Access Compliance Report

Public Rights-of-Way

Intersection ID: 28715	Main Street: EAGLE_CREEK_DR	Cross Street: DELAMERE_LN	Location: E
ADA ID: 08DC5335CDEB	Ramp Type: PerpDiag	Initial Pass/Fail: Fail	Overall Compliance: No
		Severity Score: 25

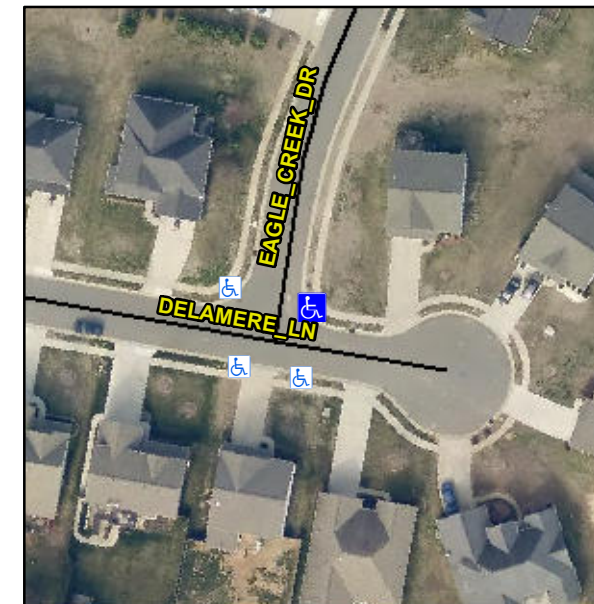
Remove & Replace Curb Ramp With Two New Directional Ramps or Equivalent.

Not Found, R304.5.3
